**PROPOSAL FOR DRAFT AMENDMENT TO REGULATION No. 43**  
(Safety glazing)

Transmitted by the Expert from the European Community 1/

**A. PROPOSAL**

"Safety glazing having a regular light transmittance < 40 per cent

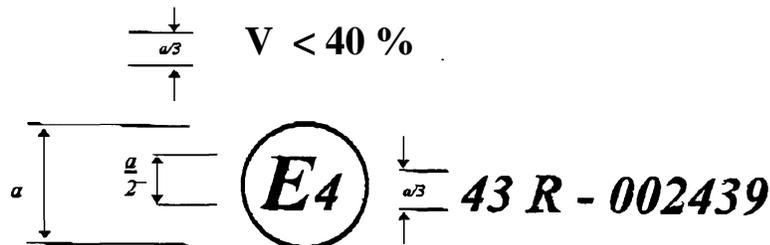
2. Annex 2A, 'ARRANGEMENT OF APPROVAL MARKS FOR COMPONENTS', add after the approval mark a new example for safety glazing having a regular light transmittance < 70 per cent, to read:

The above approval mark affixed to a safety glazing with a regular light transmittance of less than 40 per cent as determined by the test described in annex 3, paragraph 9.1, shows that the component concerned has been approved in the Netherlands (E 4) pursuant to Regulation No 43 in its original form under approval No. 002439. The approval number indicates that the approval was granted in accordance with the requirements of Regulation No 43"

*a = 8 mm min.*
